Application X/23/94736
Please ask for Liz Harrison
Direct dial 023 8068 8284
Working hours
Email liz.harrison@eastleigh.gov.uk

Application No: X/23/94736
Description: Variation of condition 1 (approved drawings) of reserved matters application RM/19/86658 (pursuant to outline planning permission O/15/75953, as amended by X/19/84943) for Boorley Gardens Phase 3 to allow revisions to the house types on plots 463-648 (with the exclusion of plots 569-577, 580, 583, 595-599 and 621-631).
Site: Land North West of Winchester Road, Boorley Green, Hampshire, SO32 2BX

Plot by plot comments

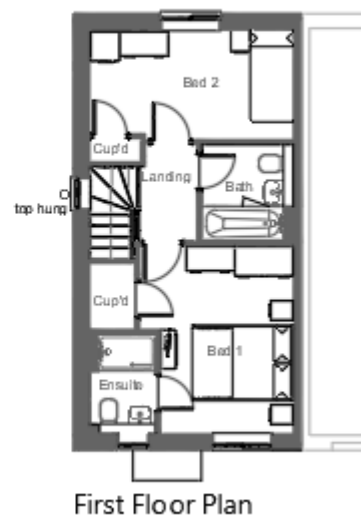
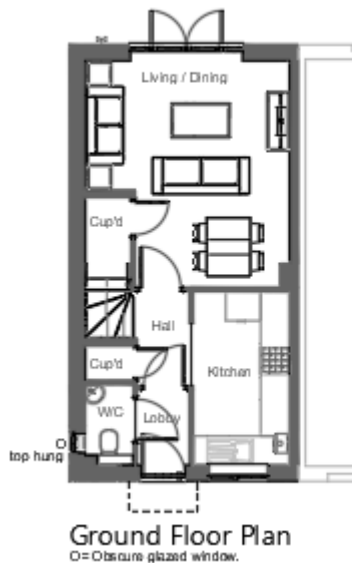
- **House Type Blemmere Y with Bay Options 1 and 2** – the porch surround should be changed to a flat porch canopy that extends across the front door and the adjoining W.C. window. This has been adjusted as suggested, as discussed and agreed at our meeting on 13 December 2023.

- House Type Cooper X Options 1 and 2** – an alternative porch canopy is required as the current design is such that it sits too close to the window headers either side. The W.C window could be moved to the side elevation to make the front elevation less crowded. In addition the side window serving the stairs should be marked as obscure glazed and top hung only on all the floor plans as it is on the elevations. The window is marked as suggested, the canopy has been adjusted as suggested and discussed at our meeting on 13 December 2023.

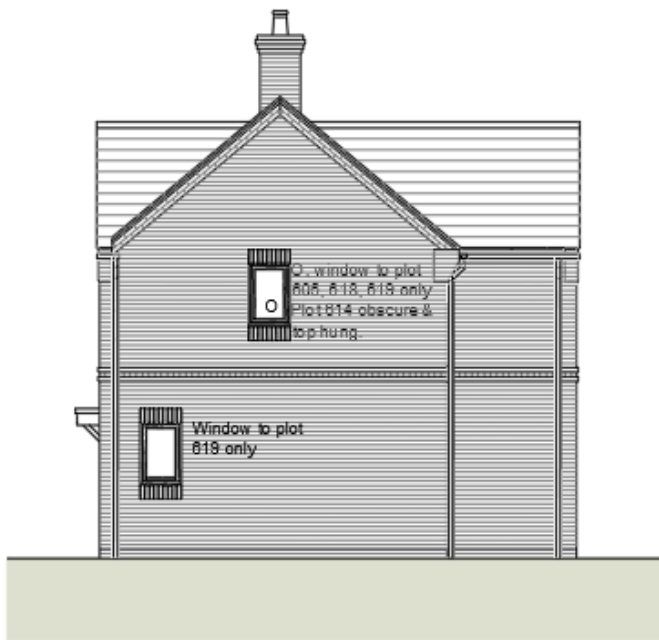
- House Type Fuller Y with Bay – Elevations Option 1 – Brick** – drawing HT.FR-Y.e1 rev A needs to be amended to show the side bedroom 1 window on plots 511, 605, 614 and 618 to be consistent with the floor plans HT.FR-Y.p rev A. The window is shown as suggested, notes adjusted in line with further comments received relating to specific plots, as well as plots removed due to being changed to different house types, as discussed and agreed at our meeting on 13 December 2023.

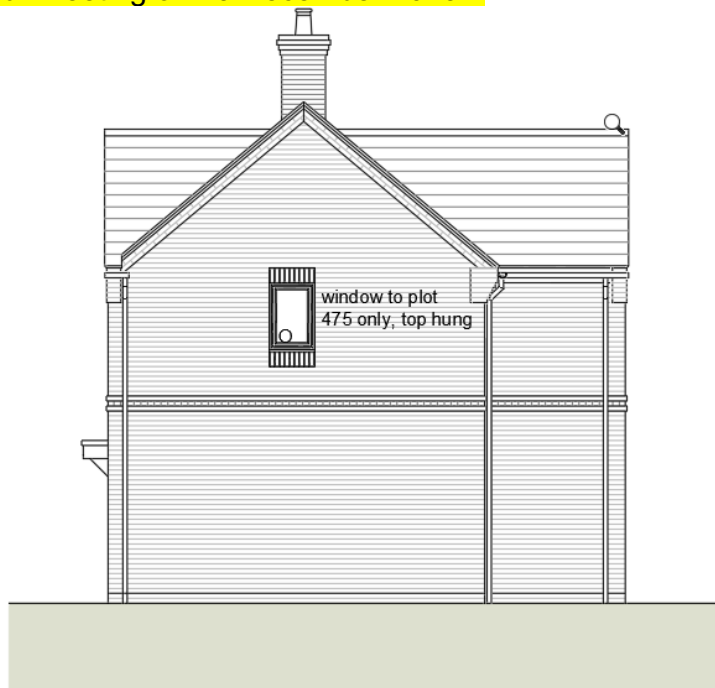
- **House Type Fuller Y with Bay - Elevations Option 2 – Painted Brick** – the annotation on drawing HT.FR-Y.e2 rev A for the side bedroom 1 window includes reference to plots that are not covered by this drawing. Please amend to only refer to plots 475 and 612 to avoid confusion. The window is marked as suggested, plot 612 removed as replaced with BO-X, as discussed at our meeting on 13 December 2023.

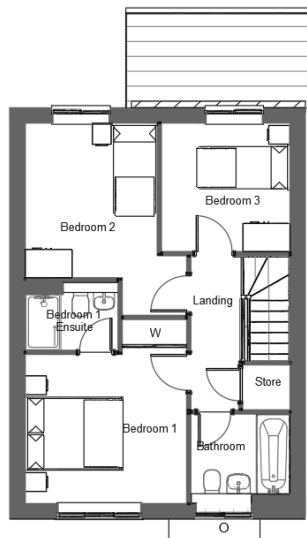
- **House Type Goldsmith X** – the floor plans and elevations are not consistent with regard to the rear bathroom window being obscure glazed. Please amend the elevations for all plots to be consistent with the floor plan. The window is marked as suggested and as discussed at our meeting on 13 December 2023.

Mason plots 478-510-613-620645-648

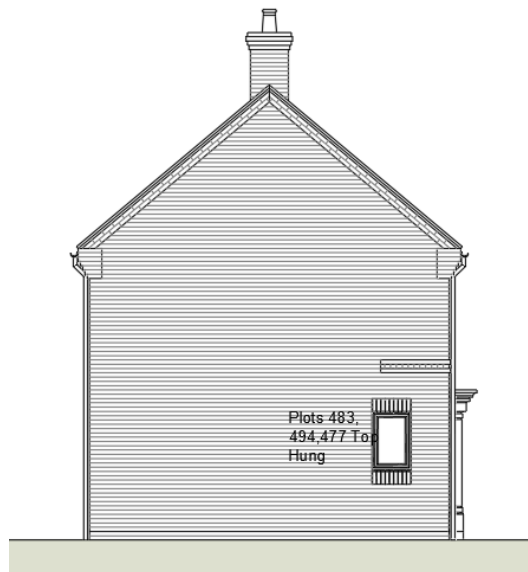
- **Plots 477, 478, 510, 608, 609, 613, 620, 645 & 648 (House Type Mason X)** – given the prominence of the side elevations in the street scene a side ground floor window should be added to the elevations facing the drives. This is adjusted as suggested, where the Mason was replaced with an other house type, the other house types has been shown with the window requested, as discussed and agreed at our meeting on 13 December 2023.

Baker 608-609

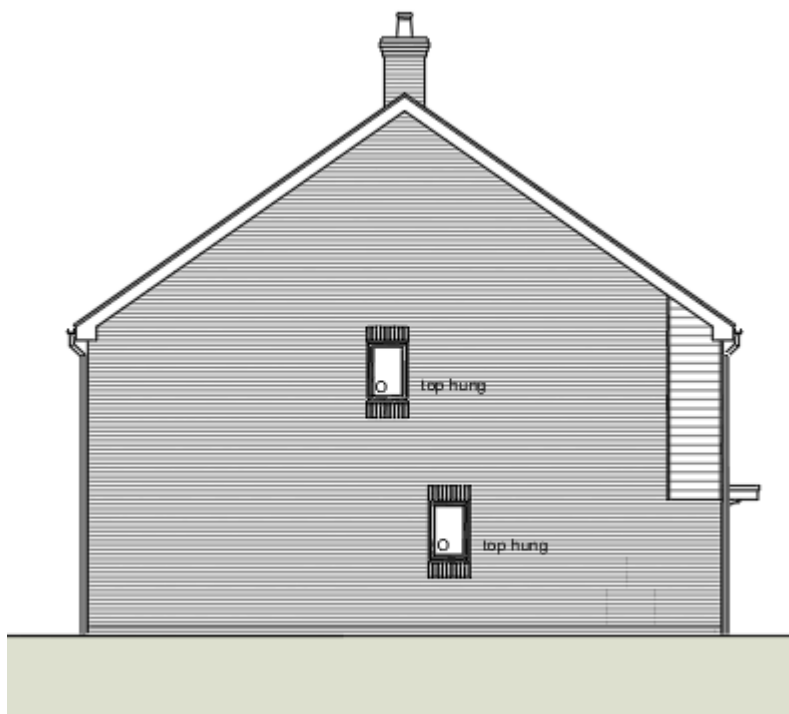
- **Plots 608 & 609 (House Type Baker X)** – the elevations and street elevation 19 are not consistent with regard to the style of porch and use of weatherboarding. In addition please note the comment above about the need to add a side ground floor window to the elevation facing the drive due to its prominence in the streetscene. This has been addressed and shown as below, as discussed and agreed at our meeting on 13 December 2023.

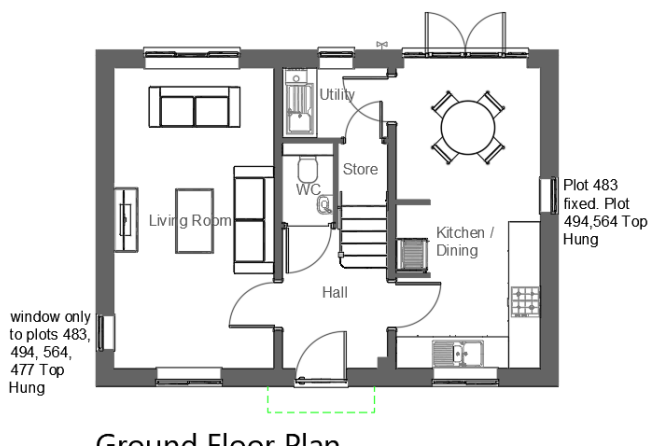
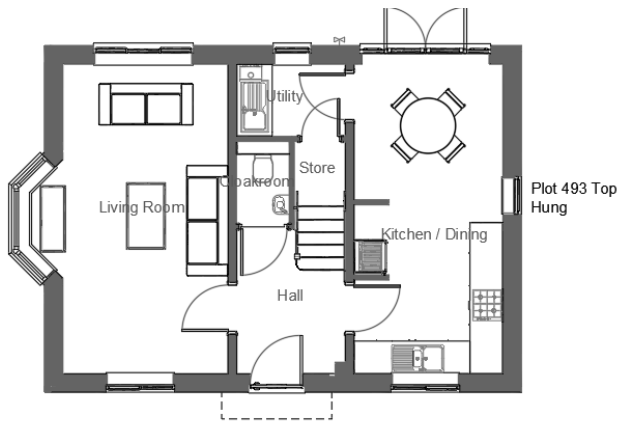
- **Plots 483 & 493 (House Type Tenterer Y)** – given the prominence of the elevations in the streetscene side ground floor windows need to be provided on both side elevations. This has been adjusted as requested and discussed at our meeting on 13 December 2023. We assume plot 493 is meant being TE-X.

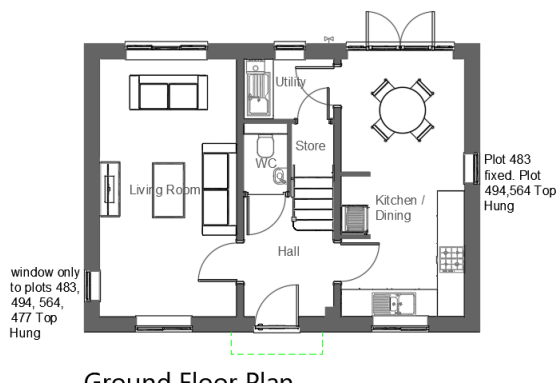
- **Plots 485 & 585 (House Type Cooper X)** – given the prominence of the side elevations in the street scene an additional ground floor window(s) needs to be provided. The WC window has been moved to the side, providing the additional ground floor window, as discussed and agreed at our meeting on 13 December 2023.

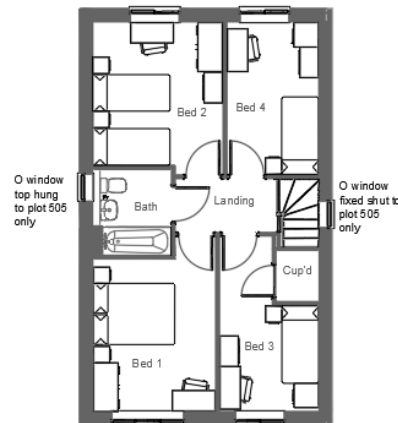
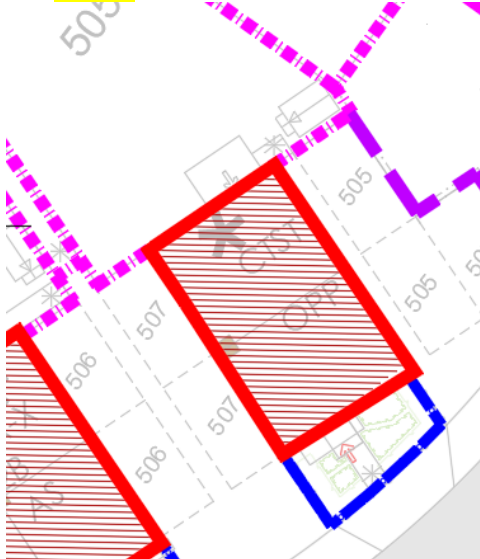
- **Plot 505 (House Type Cartographer X)** – the unit on this plot should be handed so that the bathroom can be provided with an openable obscure glazed and top hung window to provide natural ventilation as well as light. The

hall and landing windows could then be the non-openable windows. This has been adjusted as suggested and discussed at our meeting on 13 December 2023.

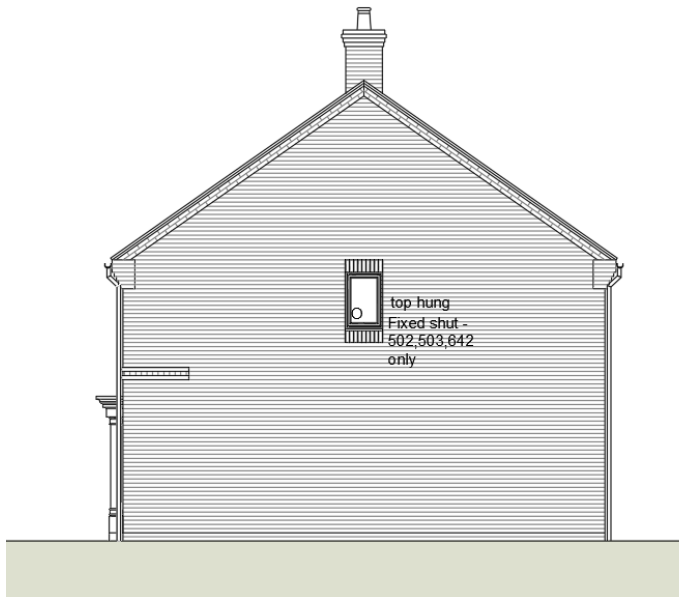
- **Plots 506-508 (House Type Baker X)** – please note the earlier comments about the problems arising from the siting and design of this terrace. This has been addressed on previous comment sheet (dated 6.11.23)
- **Plot 511 (House Type Fuller Y with Bay)** - the side bedroom 1 window should be annotated as obscure glazed and top hung only to avoid undue loss of privacy for plot 512. This unit is now a Bowyer, the comments have been addressed with regards to windows, as discussed and agreed at our meeting on 13 December 2023.

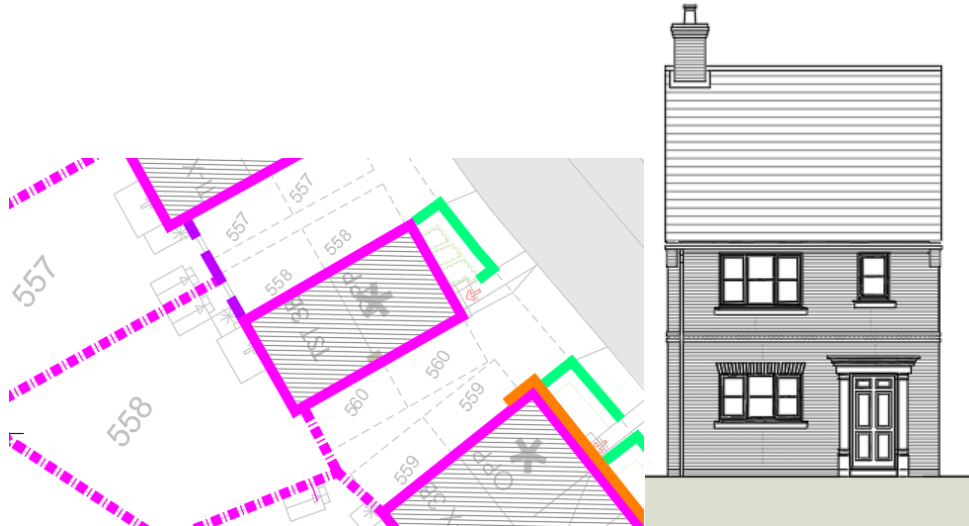
- **Plot 558 (House Type Tillman X)** – as noted in the previous comments the use of the Tillman house type on this plot is not appropriate as it is too narrow a house type with the front door and porch canopy very close to the side elevation. It reads as if it is half of a pair of semi-detached properties, with the other half missing, which is effectively what it is given that it is how it is used elsewhere on the site. In amending the house type proposed for this plot, please consider the handing of the unit and how that impacts on the provision

of openable bathroom windows as if the proposed Tillman (which is not acceptable) had been handed on this plot it could have been provided with an

openable obscure glazed and top hung window, rather than one that was fixed shut. In addition the house type on this plot should have a chimney as was proposed on the approved plans. The wider stretched Tillman version is proposed, the unit has been handed, as discussed and agreed at our meeting on 13 December 2023.

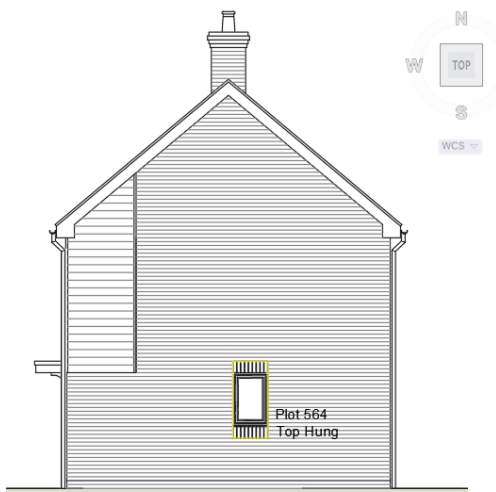
- **Plot 560 (House Type Ploughwright X)** - the use of the Ploughwright X on this plot, with its blank ground floor window on the front elevation is not appropriate on this very important corner plot facing the public open space to the south. An alternative house type is required in this location. As mentioned above, the Ploughwrights have been replaced with a stretched affordable version of the Blemmere, as discussed and agreed at our meeting on 13 December 2023.
- **Plot 564 (House Type Goldsmith X)** – given the prominence of the side elevation in the streetscene and from the public open space, a side dining window should be added, as it is for plot 530. This is now a Tenterer-Y, as discussed and agreed at our meeting on 13 December 2023.

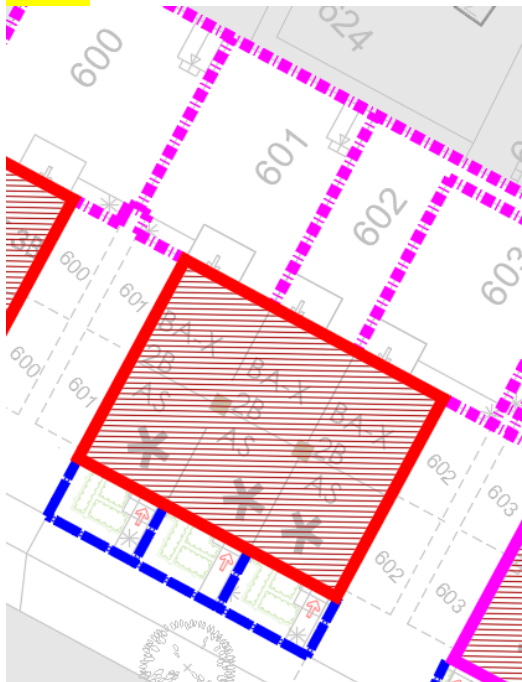
- **Plots 581 & 582 (House Type Spinner X)** – an alternative porch canopy is required as the current design is such that it sits too close to the header for the
- W.C window. In addition the kitchen windows do not need to be top hung and can be fully openable. This has been adjusted as suggested and discussed at our meeting on 13 December 2023.

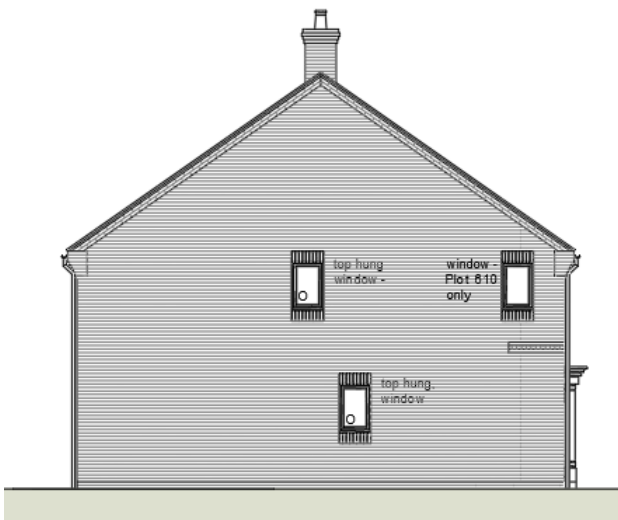
- **Plot 607 (House Type Cooper)** – please note the earlier comments about the use of semi-detached units on plots 606-607 and the resultant need for 3 sets of tandem parking spaces which is not acceptable. In amending the plans

please note that the current porch design is not acceptable as it sits too close to the window headers either side.

This has been revised as below, as discussed and agreed at our meeting on 13 December 2023.

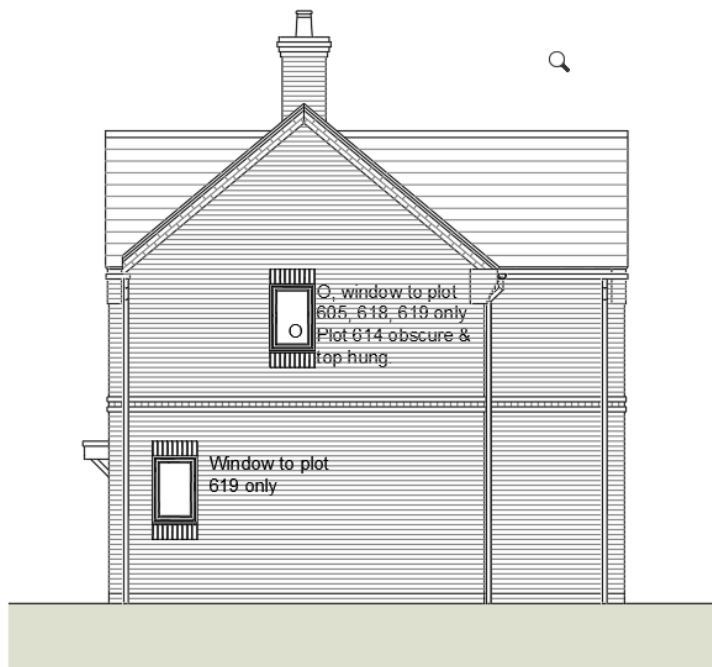
- **Plot 610 (House Type Baker X)** – given the prominence of the side elevation in the streetscene an additional side window(s) should be provided. An additional first floor window has been incorporated, as discussed at our meeting on 13 December 2023.

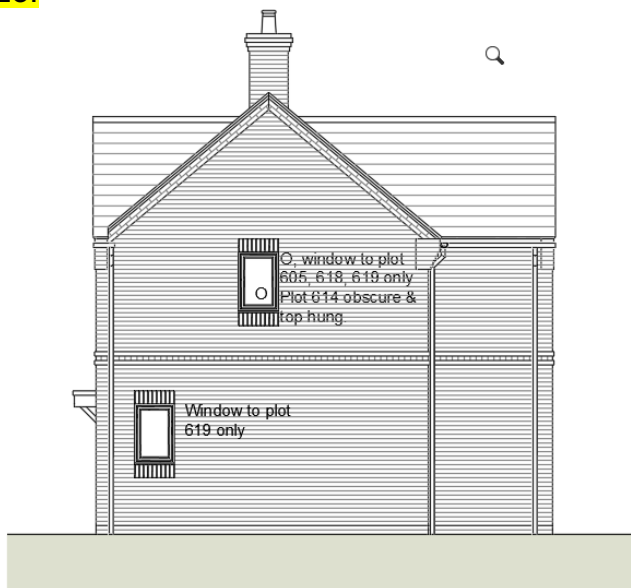
- **Plot 619 (House Type Fuller Y with Bay)** – given the prominence of the side elevation in the streetscene living room windows should be provided on the side elevation facing the drive. In addition the floor plans and elevations are not consistent with regard to the side bedroom 1 window, so please also amend the side elevation to show that window. This has been addressed and shown as below, as discussed and agreed at our meeting on 13 December 2023.

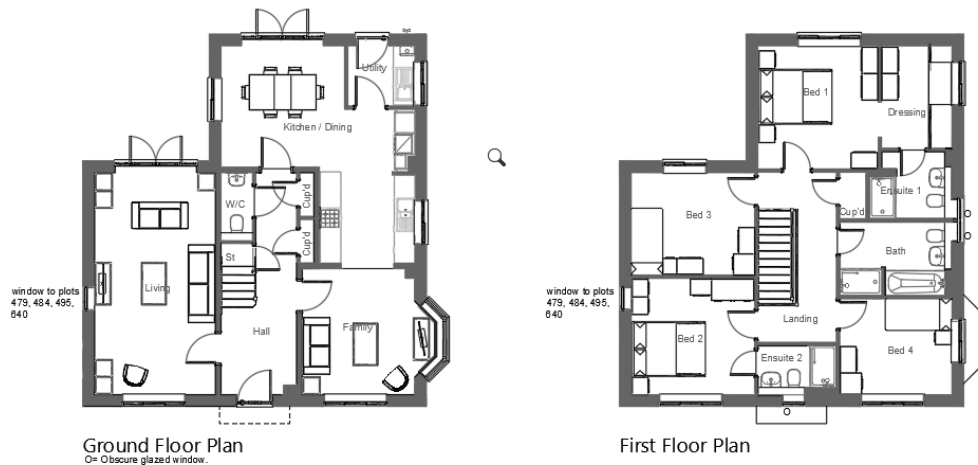
- **Plot 640 (House Type Weaver X with Bay)** – given the prominence of the side elevation in the streetscene side, living room and bedroom 2 windows should be provided, as they are for plots 484 and 495. In addition please note the comments above about the need to amend the proportions of the windows on the side elevation so they have the same proportions as the other windows. This has been addressed and shown as below, as discussed and agreed at our meeting on 13 December 2023.

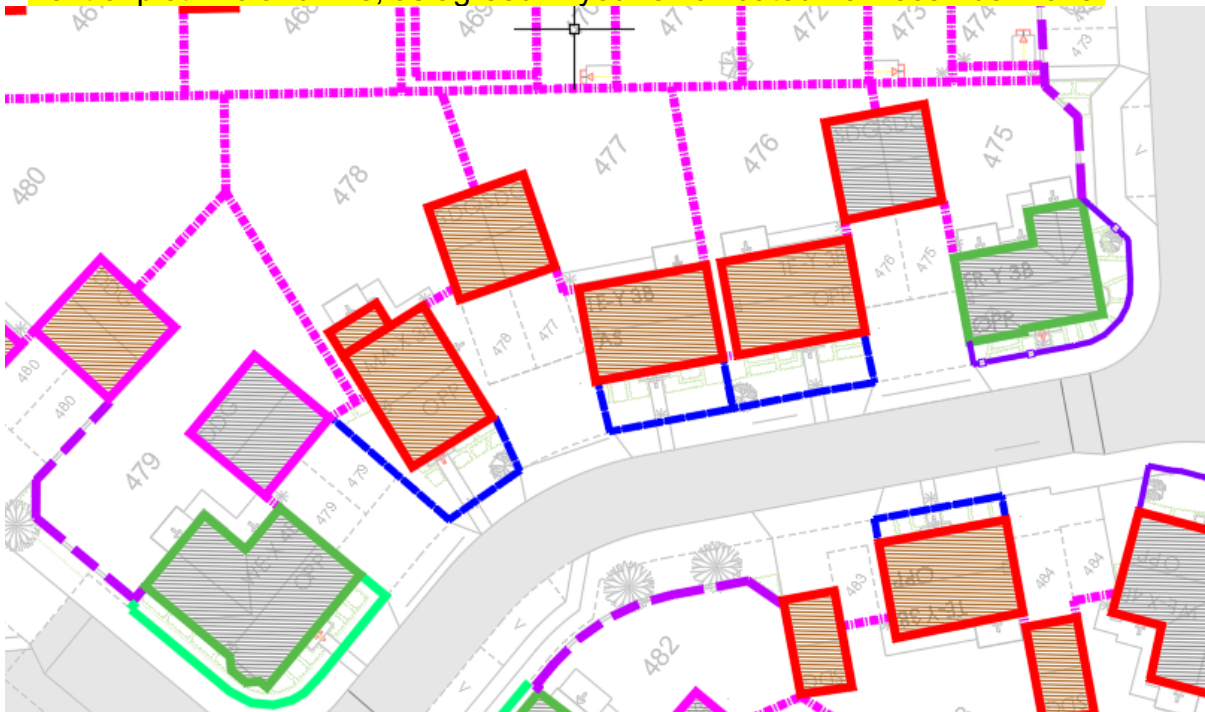
- Plots 493, 494, 497, 498, 500, 506, 508, 510, 521, 522, 523, 524, 551, 565, 567, 578, 579, 600, 601, 602, 603, 604, 605, 612, 636, 637, 638, 639, 641, 648– the front boundary fences and railings need to be extended so they join with another boundary or the side elevation of the properties to give protection to the proposed landscaping which is otherwise likely to be removed/walked across due to the desire line from the drive to the front door without going onto the pavement, or to provide appropriate defensible space and a well designed streetscene. Some examples highlighted in green or yellow are given below: This has been adjusted as suggested and discussed at our meeting on 13 December 2023.
